AREVA Enrichment Services LLC  
Eagle Rock Enrichment Facility  
NRC Docket No: 70-7015

Subject: Notice of Organization Change for the Eagle Rock Enrichment Facility License Application

Enclosure: 1) AES Organization Change, Marked-up Pages for the Safety Analysis Report and the Quality Assurance Program Description

### **Marked-up Pages for the Safety Analysis Report and the Quality Assurance Program Description**

**Figure 1-2** **Rev. 2**  
Engineering, Procurement and  
Construction (EPC) Organizational Chart  
**EAGLE ROCK ENRICHMENT FACILITY**  
**QUALITY ASSURANCE PROGRAM DESCRIPTION**

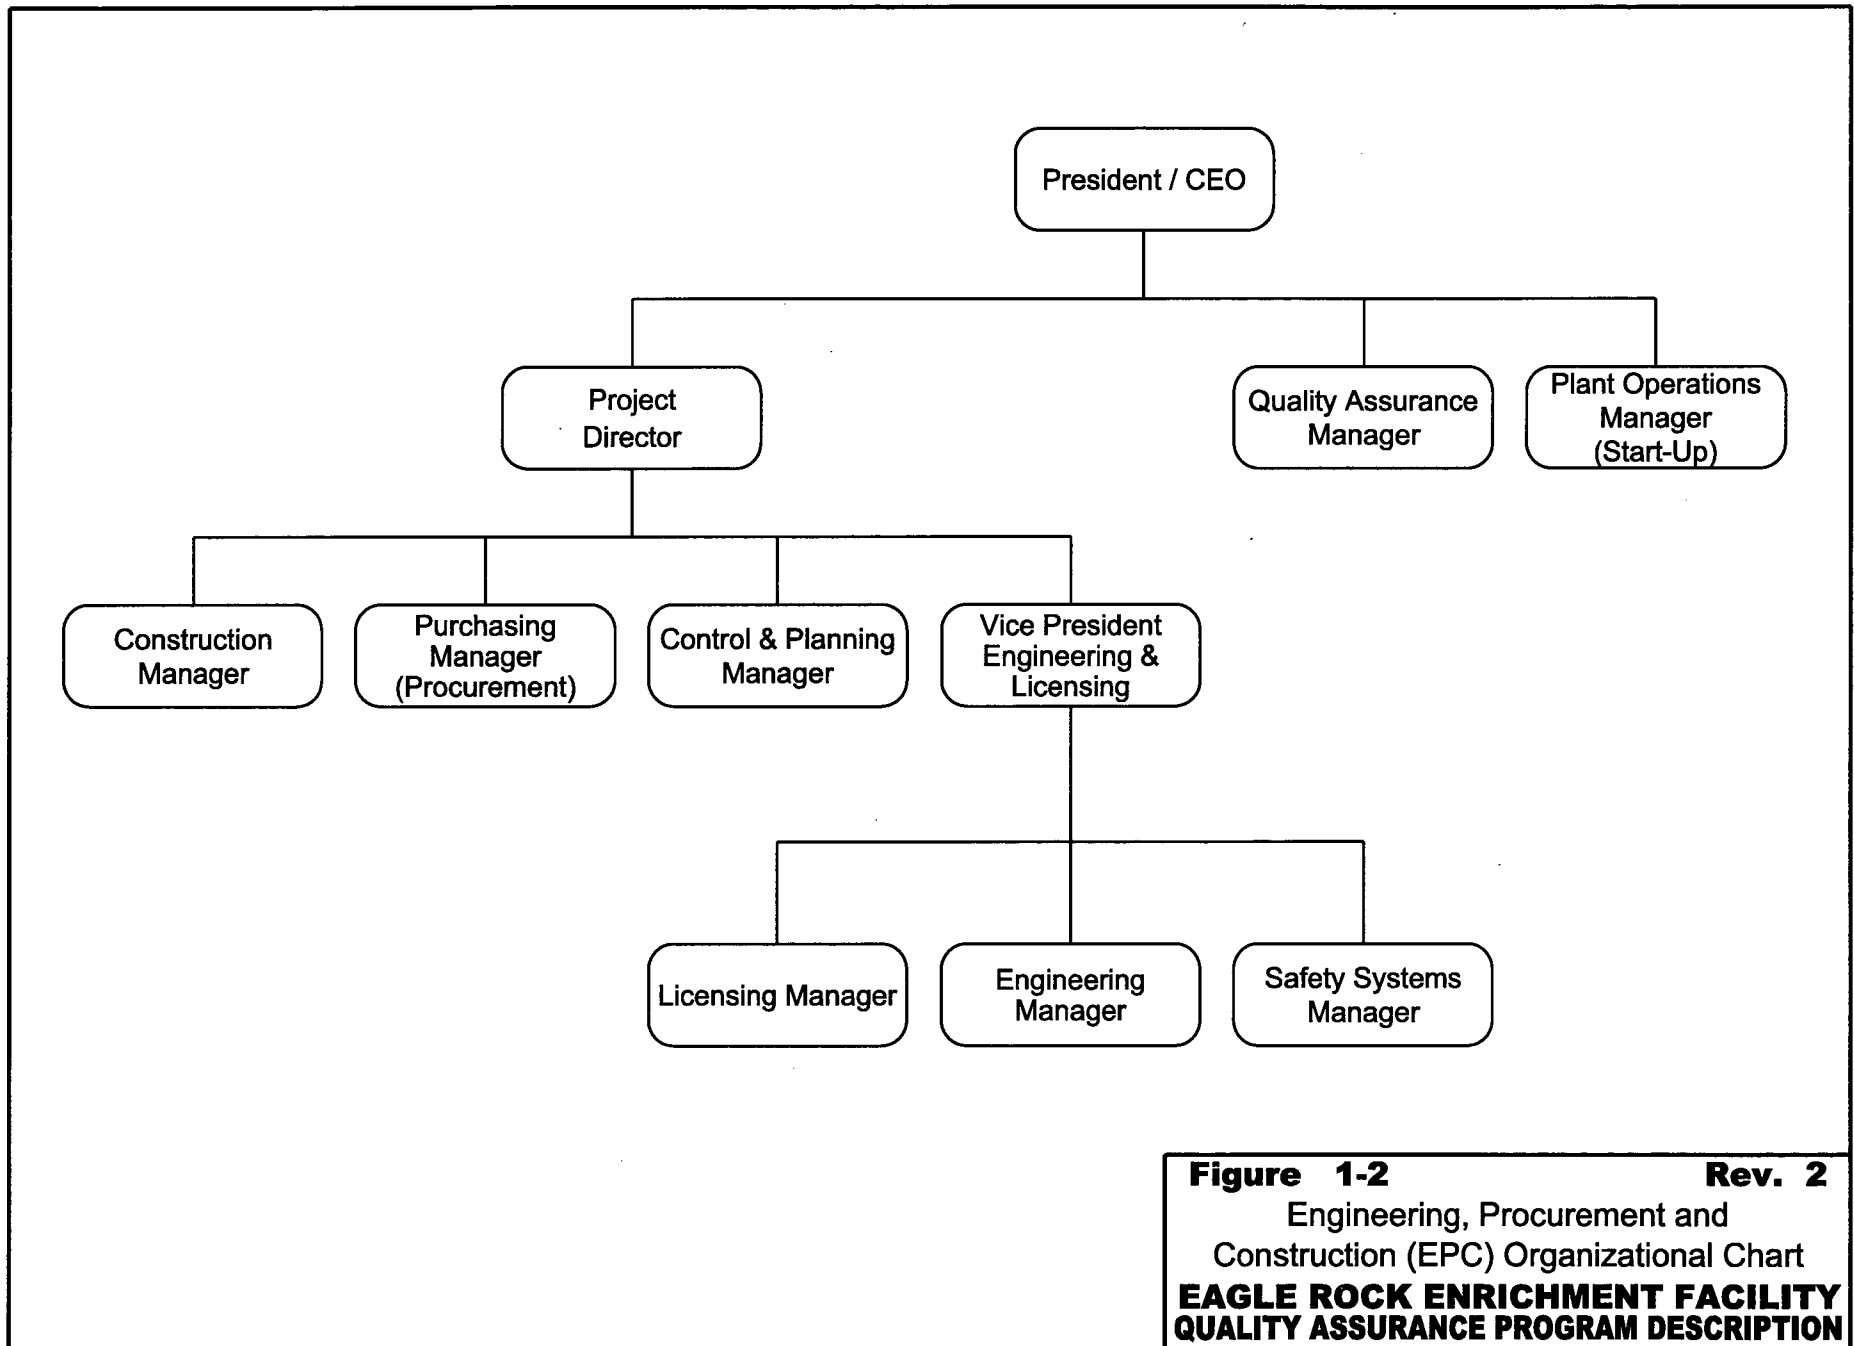
- 1.2.3 The AES President has designated the ~~Vice President Engineering and Engineering, Procurement and Construction (EPC) Project Manager~~ the responsibility for design, construction, procurement, and initial start-up for the Eagle Rock Enrichment Facility. The QAPD is binding on all AES and contractor personnel involved with the Eagle Rock Enrichment Facility.

- 1.2.4 ~~A Deputy EPC Project Manager may assist the EPC Project Manager in planning and implementation of EPC activities.~~
- 1.2.5 The AES President has designated the Plant Manager the responsibility for operation, maintenance, and associated support activities for the Eagle Rock Enrichment Facility.

The AES President has designated the Plant Operations Manager the responsibility for initial start-up for the EREF.
